Landscape Referral Response

Application Number:	Mod2024/0473
Date:	12/09/2024
Proposed Development:	Modification of Development Consent DA2020/0393 granted for demolition works and construction of a shop top housing development comprising retail premises, 49 dwellings, basement carparking and landscaping
Responsible Officer:	Kye Miles
Land to be developed (Address):	Lot 1 DP 1199795 , 28 Lockwood Avenue BELROSE NSW 2085

Fig.1 Comparison of the approved scheme entry off Glenrose Place (left) and the proposed scheme (right).

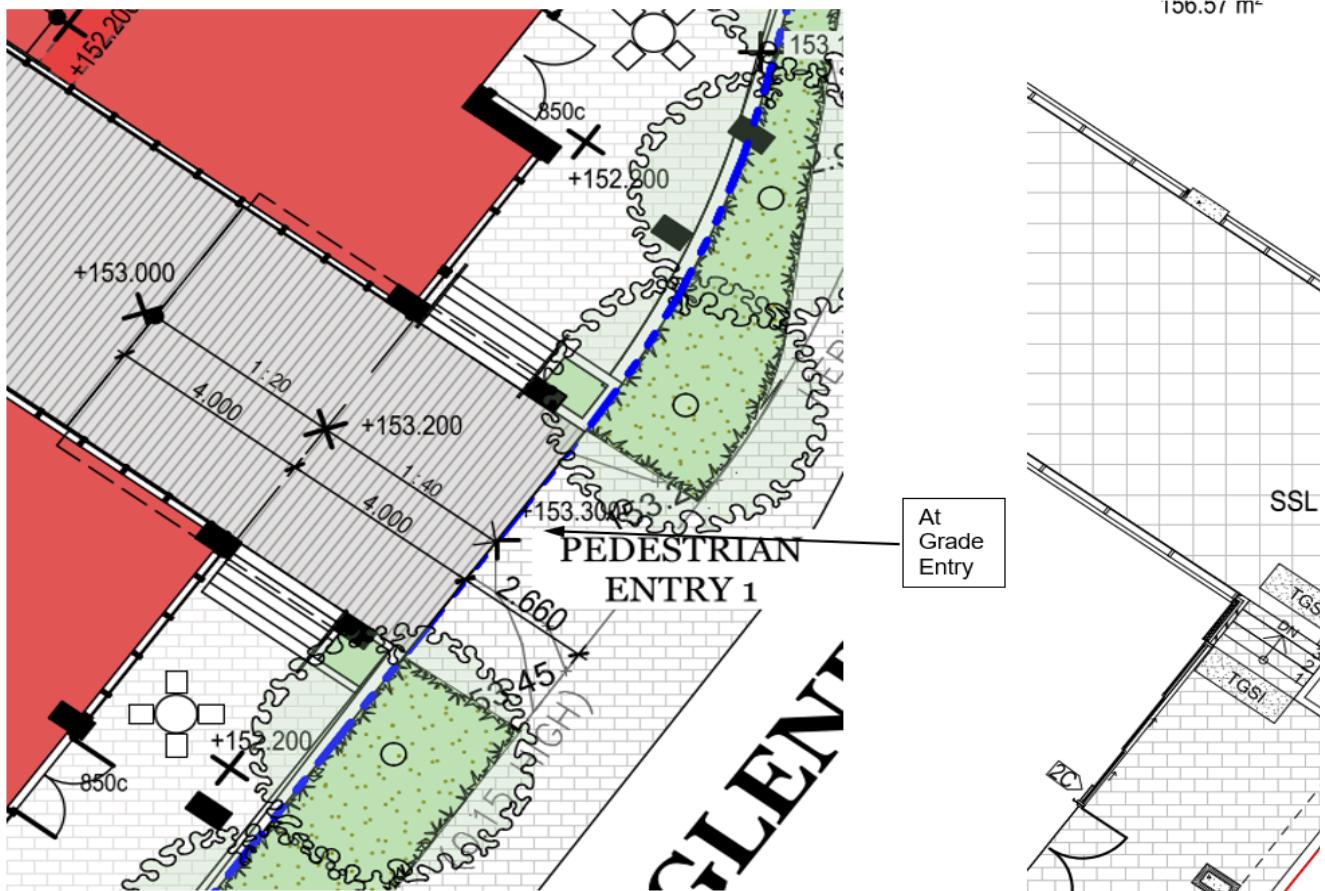
1. Entry off Glenrose Place

The approved plans provide a wide, at grade pedestrian entrance form Glenrose Place. This provided an inviting entrance to the courtyard area in terms of visual connection and ease of access between the site and the Glenrose Shopping Centre.

The proposed plans alter the level of entry. The entrance to the courtyard area is now indicated to incorporate stairs and a wall at this important entry point, which is considered to be a poorer design outcome to the approved plans as the link between the site and Glenrose Shopping Centre is diminished. (Fig.1)

Fig.2 Comparison of the approved courtyard scheme (left) and the proposed scheme (right).

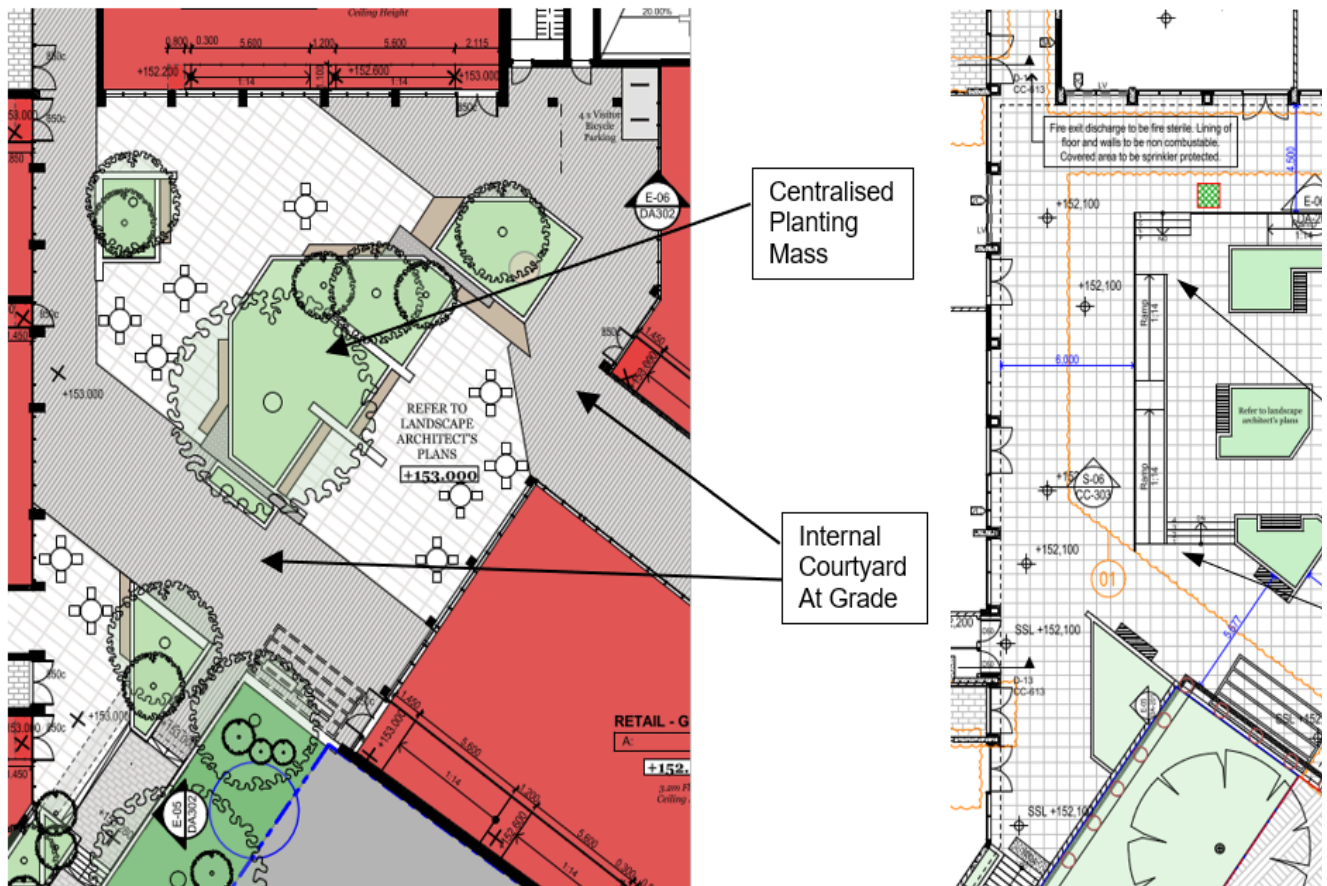
2. Internal Courtyard Planters and Levels.

The approved plans are based on a level area across the courtyard, flowing between retail outlets, seating and pedestrian space. The internal courtyard now includes a series of ramps and stairs to between the main passive component of the courtyard and the retail space access and unit access ways. The stairs and ramps alter the spaces previously provided and affect the permeability of the courtyard space.

The approved plans accommodate centralised planters providing adequate soil volume to support the approved planting scheme of trees, palms, shrubs and ground-covers. The modification requires the planters to be separated into narrower, smaller units which are unlikely to support the planting scheme as previously approved. (Fig.2).
